<b>REFERENCE:</b>	<b>TSB:</b> 14-010-24 <b>GROUP:</b> 14 - Fuel System	<b>Date:</b>	December 20, 2024	<b>REVISION:</b>	14-006-23
<b>VEHICLES AFFECTED:</b>	<b>2023 (JT) Jeep Gladiator</b> This bulletin applies to vehicles built on or after December 01, 2022 (MDH 1201XX) and built on or before February 20, 2023 (MDH 0220XX) equipped with a 3.6L V6 24V VVT Engine Up Grade I W/ESS (Sales Code ERC).			<b>MARKET APPLICABILITY:</b>	
				<input checked="" type="checkbox"/> NA	<input checked="" type="checkbox"/> MEA
				<input checked="" type="checkbox"/> SA	<input checked="" type="checkbox"/> IAP
				<input checked="" type="checkbox"/> EE	<input checked="" type="checkbox"/> CH
<b>CUSTOMER SYMPTOM:</b>	<b>Customers may experience the following:</b> <ul style="list-style-type: none"> <li>Fuel gage reading incorrectly at 7/8 full after refueling.</li> </ul>				
<b>CAUSE:</b>	Fuel level sending unit float arm catching under vent line at top of the tank

This bulletin supersedes Technical Service Bulletin (TSB) 14-006-23, date of issue July 29, 2023, which should be removed from your files. All revisions are highlighted with **\*\*asterisks\*\*** and include an updated part number in the Spare

**Fig. 1**

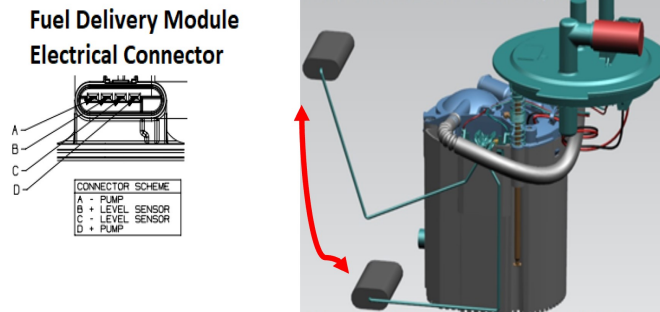
1. Remove the existing fuel tank assembly. Refer to the detailed service procedures available in DealerCONNECT> Service Library under: 09 - Engine, 3.6L / Fuel System / Tank, Fuel / Removal.
2. Using a multimeter, perform an electrical resistance test of the fuel delivery module in 2 level sensor positions “empty stop” (51 Ohms) and “full stop” (992 Ohms) fuel delivery module electrical connector pins “B” and “C” Fig. 1.

3. Did the fuel delivery module pass the electrical resistance test?
  - YES >>> Reuse the existing fuel delivery module. Proceed to [Step 5](#).
  - NO >>> Install a new fuel delivery module. Proceed to [Step 4](#).
4. Replace the fuel pump delivery module with a new O-ring and module into the new fuel tank. Refer to the detailed service procedures available in DealerCONNECT> Service Library under: 09 - Engine, 3.6L / Fuel System / Modules / Removal and Installation.
5. Install the existing fuel delivery module with a new O-ring into the new fuel tank.
6. Install new the fuel tank assembly. Refer to the detailed service procedures available in DealerCONNECT> Service Library under: 09 - Engine, 3.6L / Fuel System / Tank, Fuel / Installation.
7. Fill the new fuel tank with the removed fuel from the old fuel tank.
8. Start the vehicle, verify no fuel leaks.
